**CITY OF DOVER**

## PLANNING TECHNICAL REVIEW COMMITTEE –AGENDA

Meeting Type: Regular Meeting  
Meeting Location: Council Conference Room, City Hall, 288 Central Ave, Dover NH 03820  
Meeting Date: **Thursday, November 6, 2025**  
Meeting Time: **10:30 AM**

SITE PLAN  
9-11 MECHANIC STREET, DOVER NH,  
ASSESSOR'S MAP 24 LOT 101  
DOVER PLANNING FILE #

**DRAINAGE DETAILS**  
**CS6011**

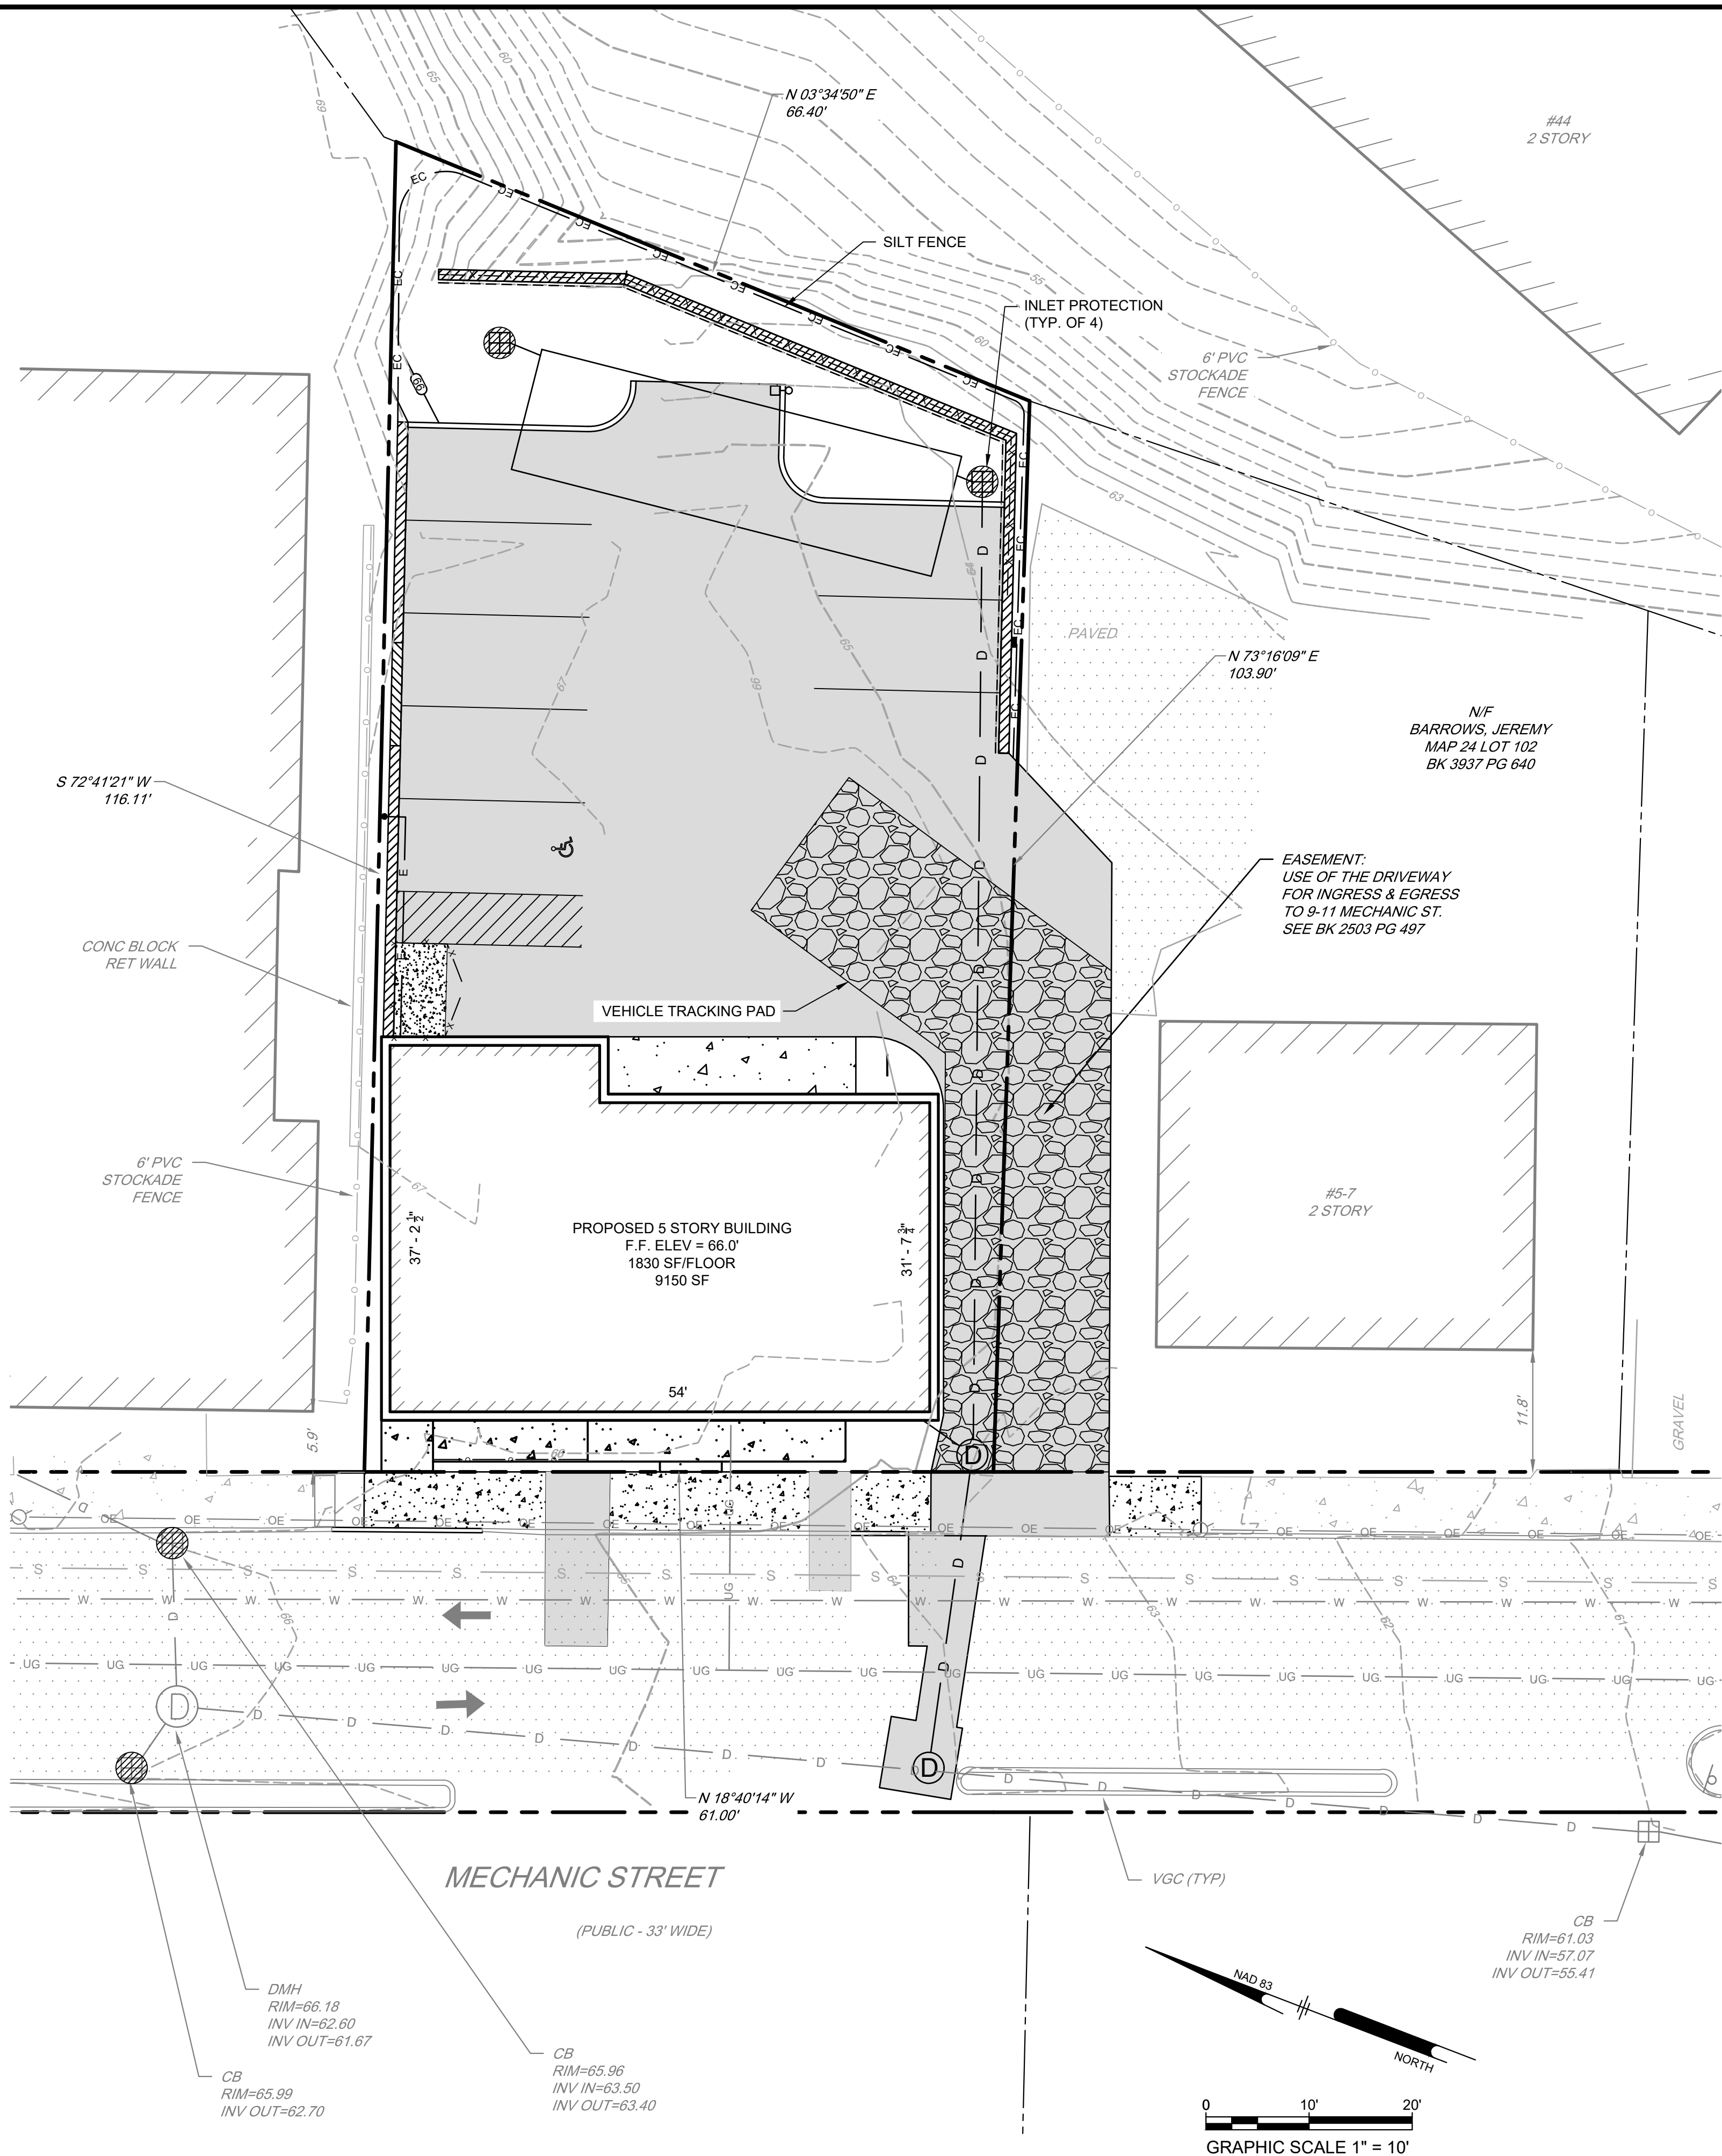
- No flush curb per City of Dover Details
  - Use City of Dover Details for concrete sidewalk minimums
- Sheet 9 of 11 Drainage Details CS6011
  - Outlet structure rim is set 3" above top elevation of berm

- **The city detail has been added to the plan.**
- Sheet 9 of 11 Drainage Details CS6011
  - Outlet structure rim is set 3" above top elevation of berm
